## 244 RX, 36 R

### CRANKCASE, IGNITION SIDE

### CARBURETTOR WALBRO WT 17 B BECOMES WT 17 C

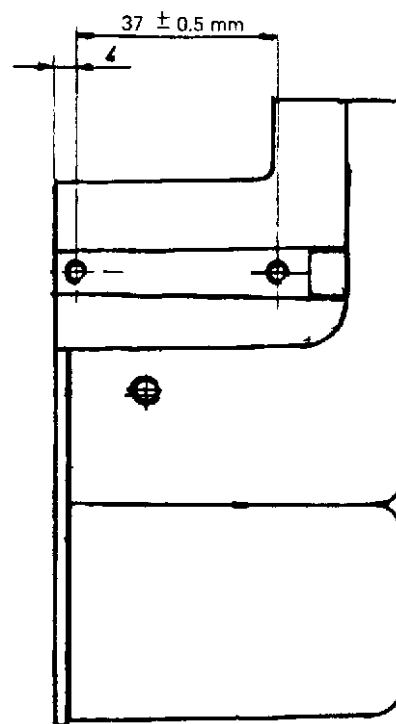
When mounting SEM AM7 coil instead of a SEM AM5 coil, the following adjustment has to be made.

The hole distance is 37 ( + 0.5) mm for AM7 compared to 46.5 ( + 0.5) mm for AM5.

Sleeve 502 05 65-02 is excluded.
